220111-SK02 P. 10/03/22
 ST. STEPHEN'S HOMELESS HUB
 GF PLAN SHOWING
 STRUCTURAL CONSIDERATIONS

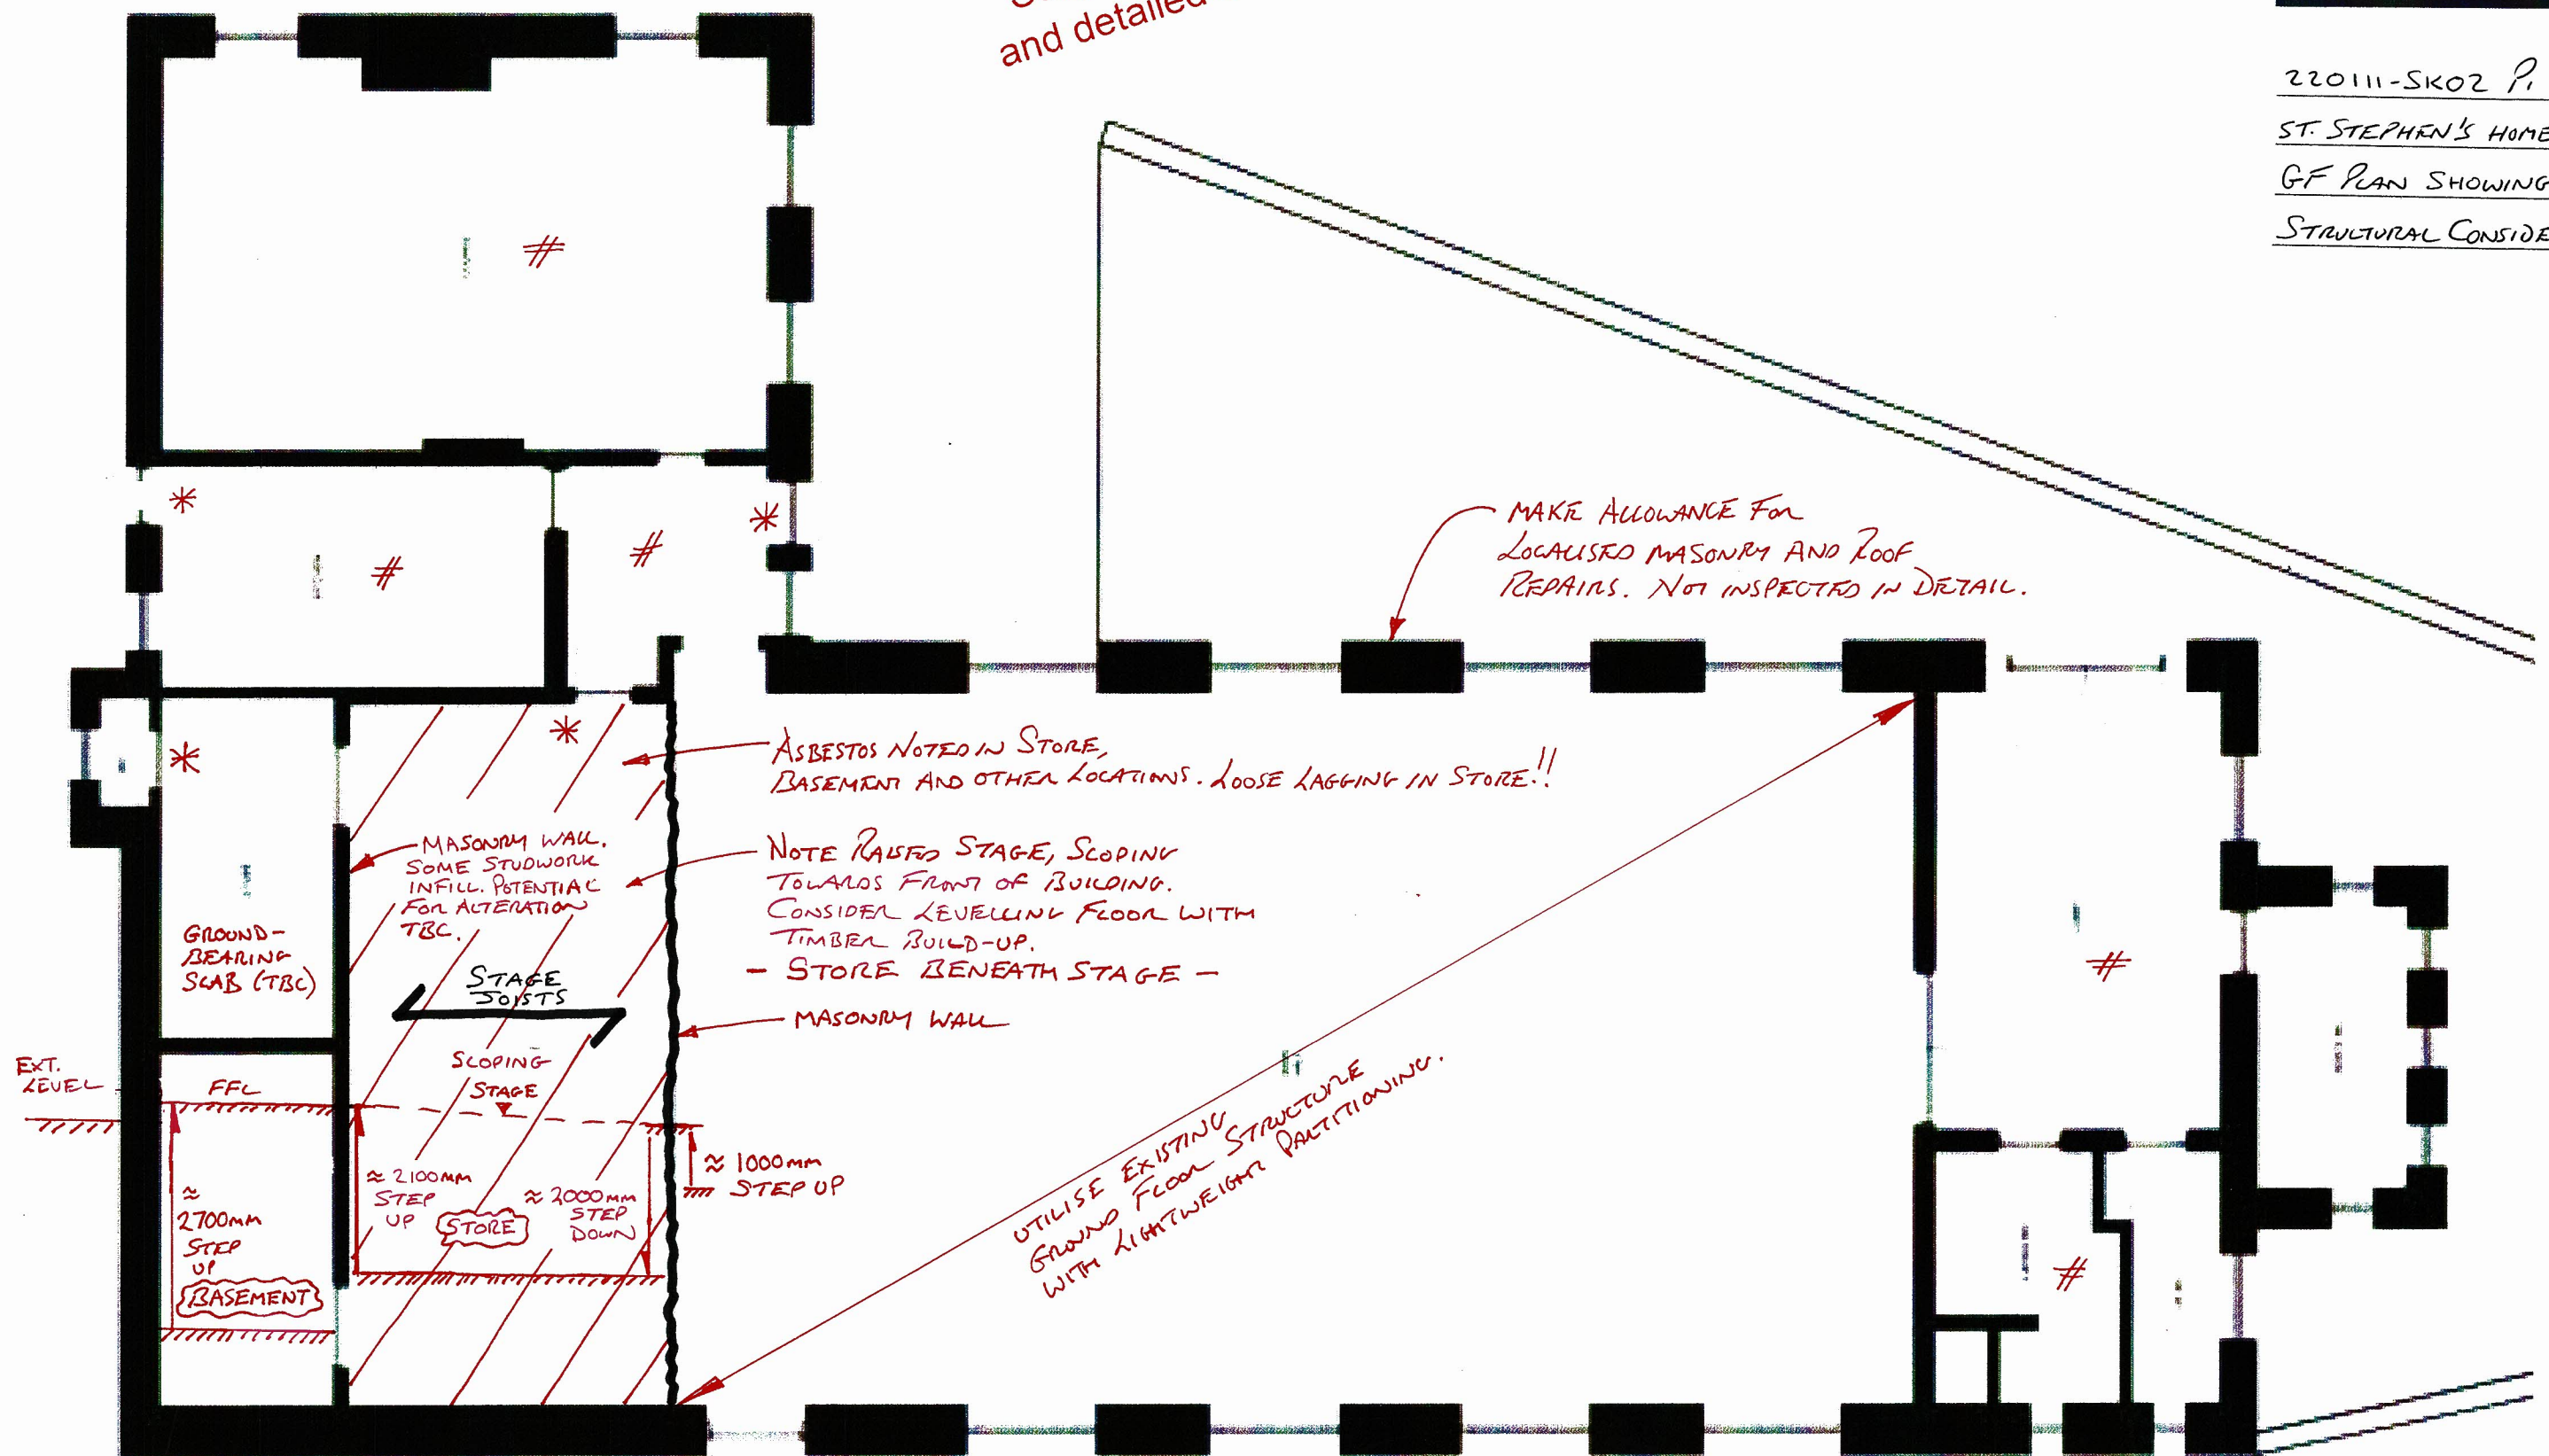
* NOTE THAT EXISTING FLOOR ARRANGEMENT WILL IMPOSE SIGNIFICANT CONSTRAINTS UPON PROPOSALS, INCLUDING RAMPED ACCESS. CONSIDER ALTERNATIVE ROUTES, MAKING USE OF REM ENTRANCES.

MAKE ALLOWANCE FOR UPPER FLOOR AND ROOF STRUCTURE MAINTENANCE AND REPAIR (NOT INSPECTED).

NOTE THAT WORKS MAY REQUIRE LISTED BUILDING CONSENT.
